Product Change Notification

105671 - 02

Change Notification #: 105671 - 02
Change Title: SC5300, PCN 105671-02, Product Design, Class 2: Sleep Button removed from bezel & thumb screws on 6-HDD cage and PS cage changed from Slot to Phillips head, Reason for Revision: Updating PCN to show TA change
Date of Publication: May 02, 2006

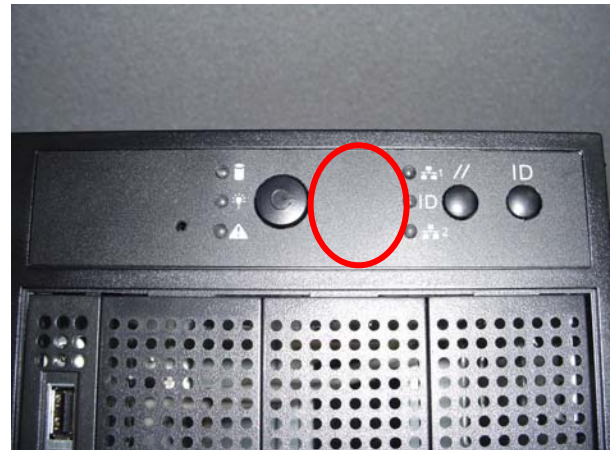
Design change to convert from a 3-button bezel to a 2-button bezel by removing Sleep button (refer to the before and after pictures below).

The thumb screw for the fixed HDD cage and the thumb screw on the power supply cage have changed from Slot to Phillips head.
